Remedy Optimization Team Report for the Bethpage Groundwater Plume Remedy

The Technical Team for Optimization of the Bethpage Plume Remedy

June 15, 2011

Response to Comments
Bethpage Optimization Report

Figure B-3

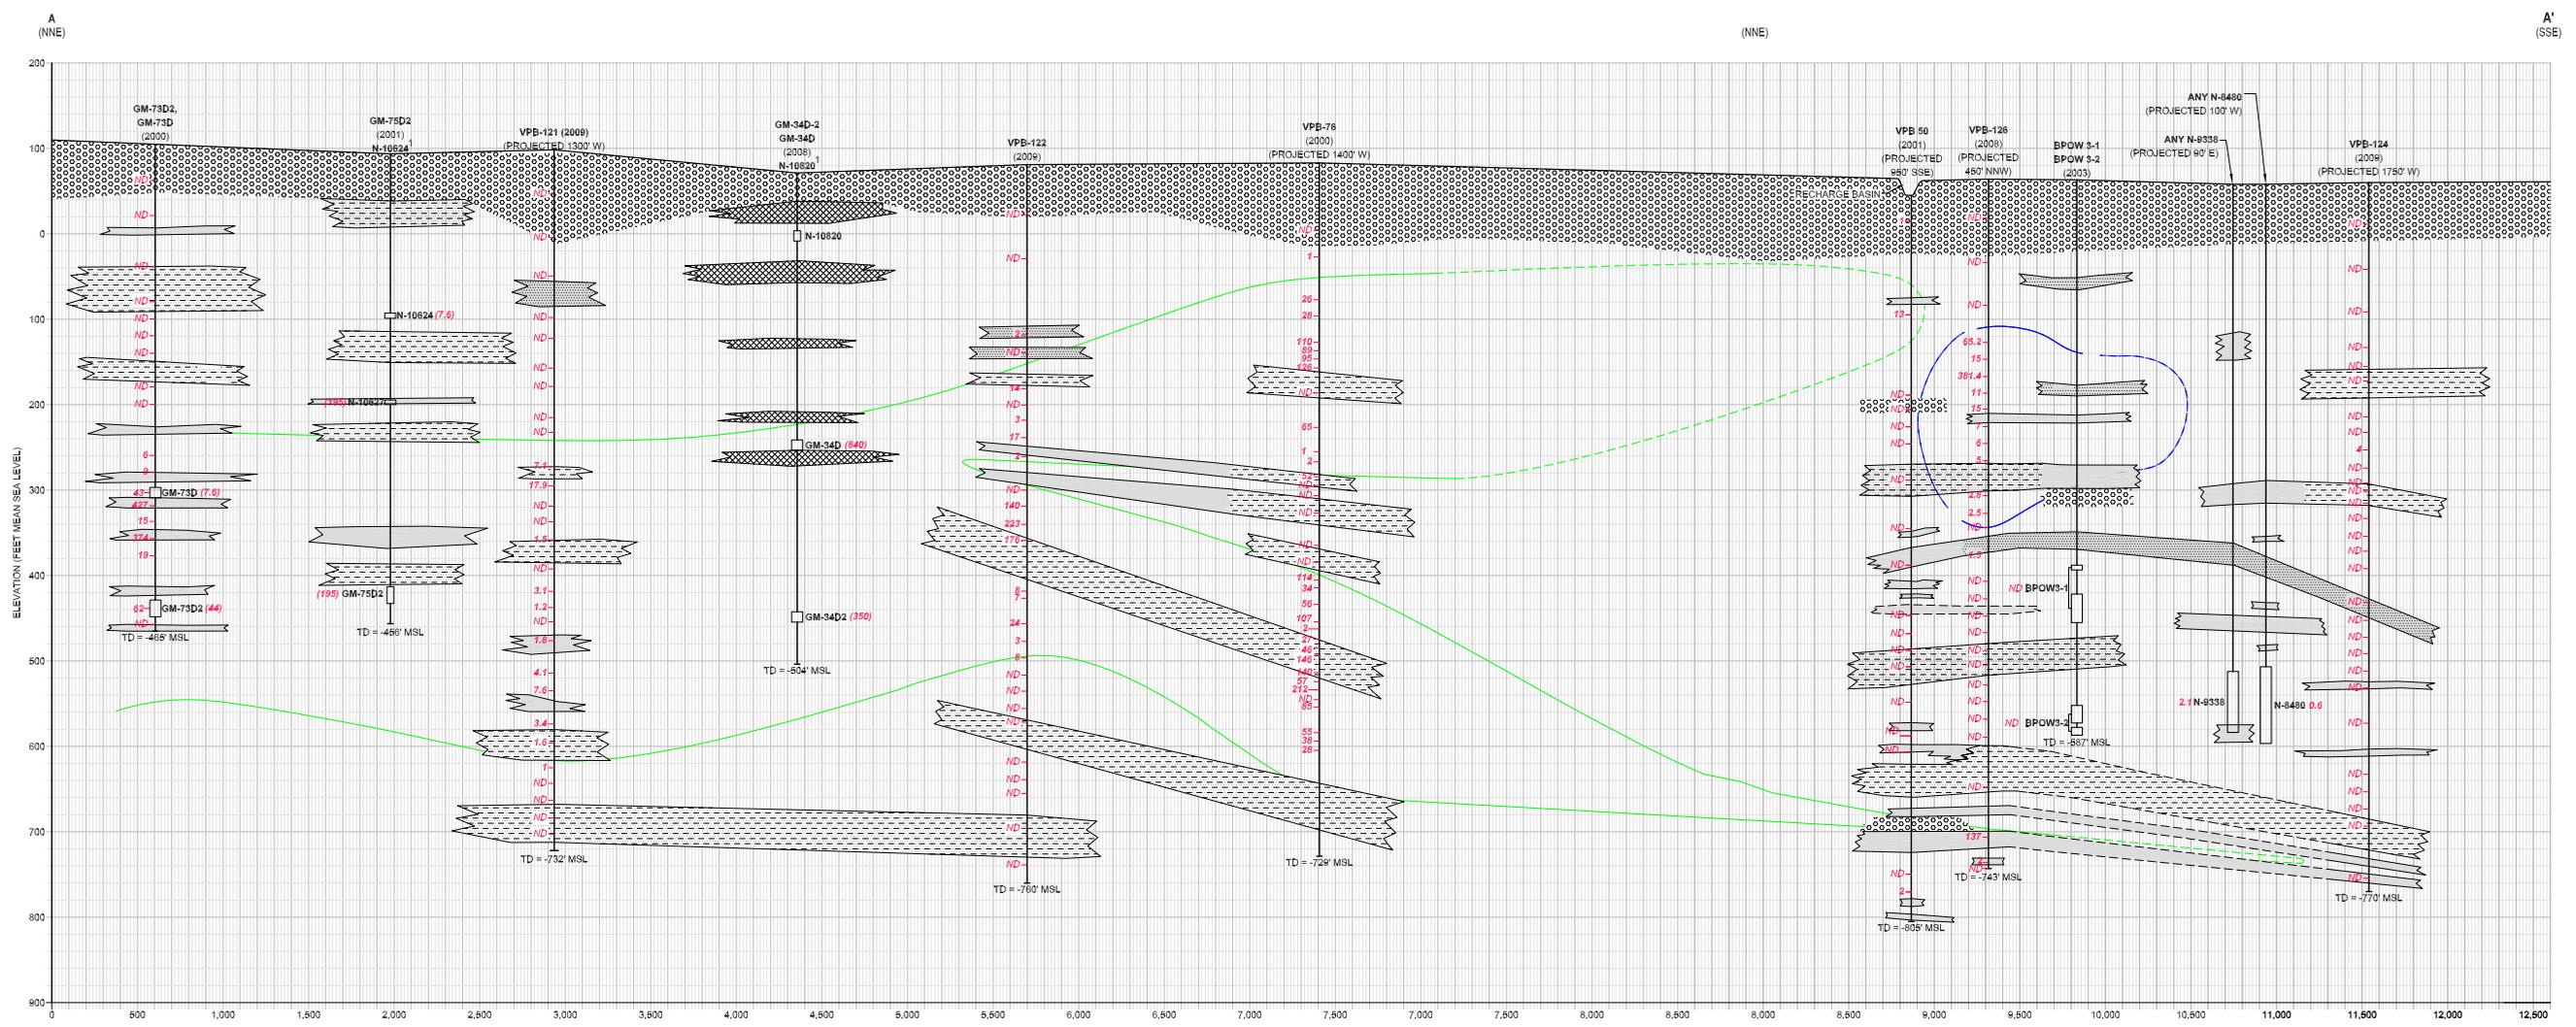
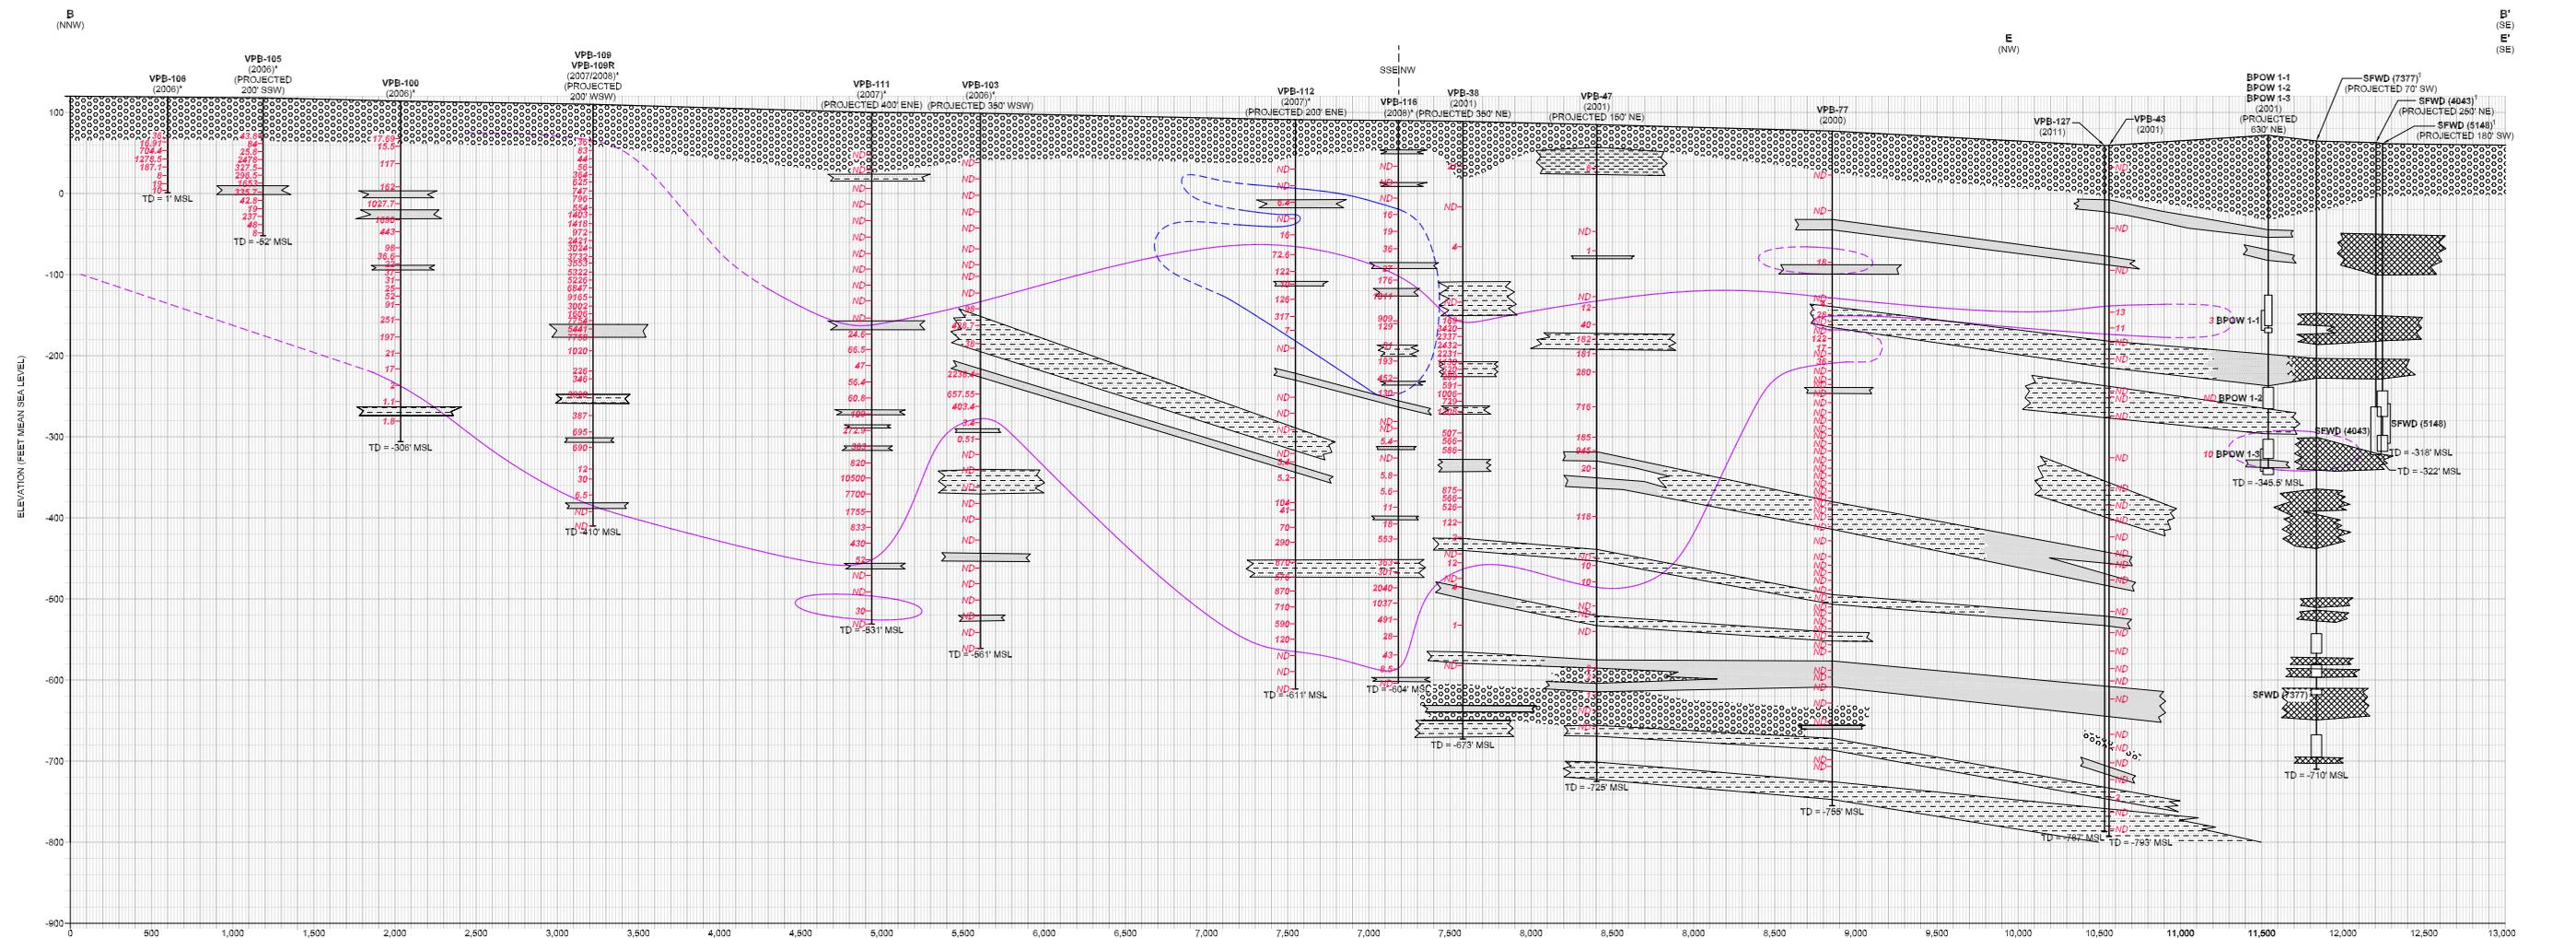
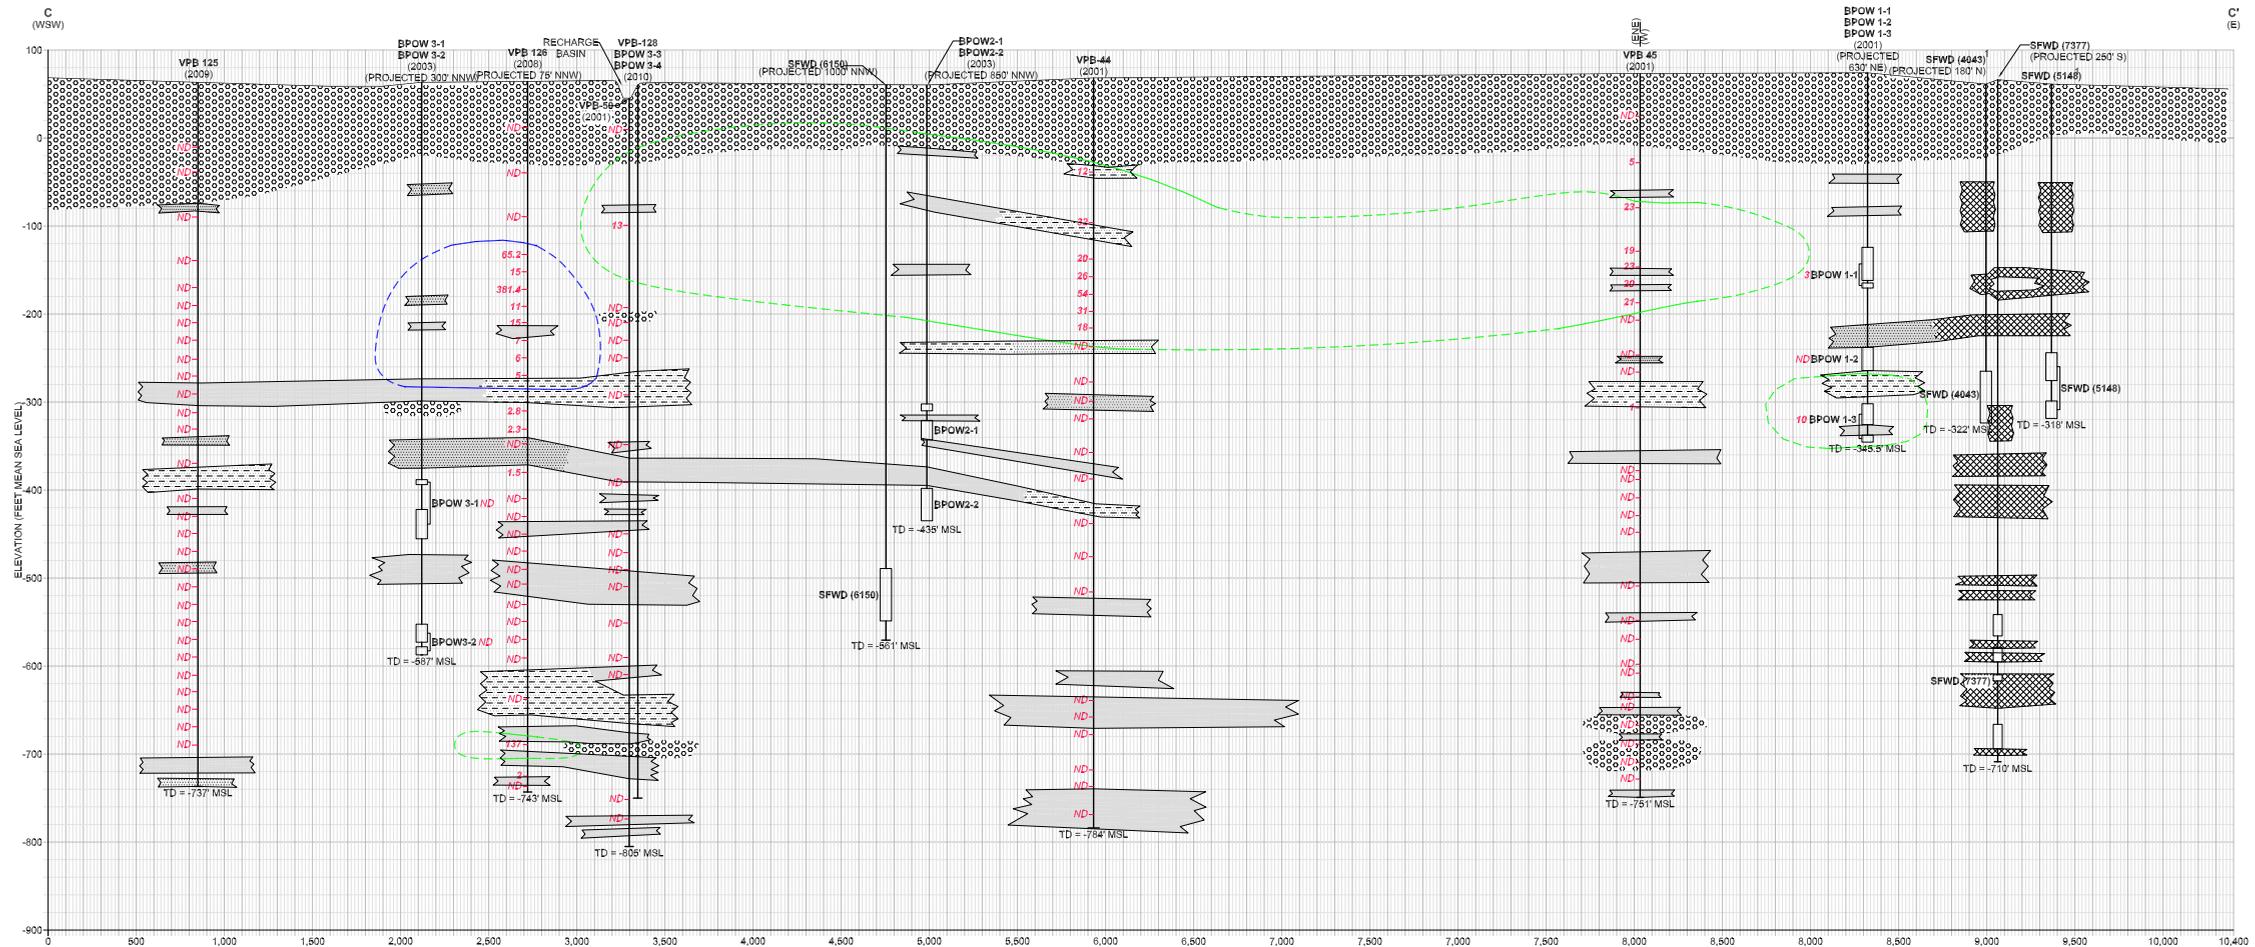
15	<p>6: Lithological Cross Sections (Appendix B)</p>	<p>Comment noted. The Technical Team agrees that limited spatial data are leading to uncertain interpretations of geologic units. This has been and will continue to be one</p>

Comment Number	Comments	Response
	<p>A number of the interpretations of low-permeability units appear to be inaccurate and not consistent with the depositional environment of the Magothy formation or the findings of the USGS and others that zones of low permeability are, for the most part, laterally discontinuous. For example: 1) some low permeability units show no dip; 2) other units show a steep dip; 3) other units arch upward; 4) various lithologic descriptions are correlated as one continuous low- permeability unit; and 5) relatively thin units are interpreted to be continuous over considerable distances. Also, the cross sections present an overly-simplified plume depiction. More detailed contouring of VOC concentrations may lead to a better understanding of plume stratification and potential sources, especially on Section B-B'. The Study Area RI Report provides a detailed analysis of VOC concentrations along a line of section similar to Section B-B' (Figure 5). Also, as stated in the Navy Work Plans, the objective of drilling to depth and mapping the upper surface of the Raritan Confining unit does not appear to have been achieved.</p>	<p>of the inherent limitations in understanding and/or modeling the groundwater flow and VOC transport at this large and complex site.</p> <p>The following additional information was provided by Tetra-Tech, the Navy contractor:</p> <p>“We acknowledge the general theory on the depositional history of soils on Long Island, as well as the general basis for the formation of low permeability units. This general theory provides a good starting point for understanding groundwater flow in the area. However, based on site-specific information, many localized variations in the general theory have been identified. In particular, based on very detailed work done on Navy property, clay units have been identified as flat (especially when viewed along the strike), steep, or even upward. The low-permeability units presented on the cross section are based on a very detailed evaluation of site-specific information and provide a good basis for understanding potential and actual groundwater and contaminant flow through the area. Where multiple borings show the same lithological signature, the units are shown as connected on the cross section. We recognize that this level of granularity would seriously limit the ability to accurately model groundwater and contaminant transport in the area, but present it because of the need to identify potential contaminant migration.</p> <p>The level of detail on the VOC contouring is likewise accurate based on the data available. This evaluation utilizes the location of known contamination and potential groundwater flow. In addition, where groundwater data are conflicting or variable, the mapping uses a conservative approach, especially where the presence of VOCs may vary based on time. For example, a water district supply well may pull contaminated groundwater from the east, west, or even south under a continuous, semi-confined seasonal pumping scenario. This condition was documented during the testing of GM-38 System, Recovery Well No. 2, where the pumping test was affected by the operation of BWD Plant No. 4.”</p>
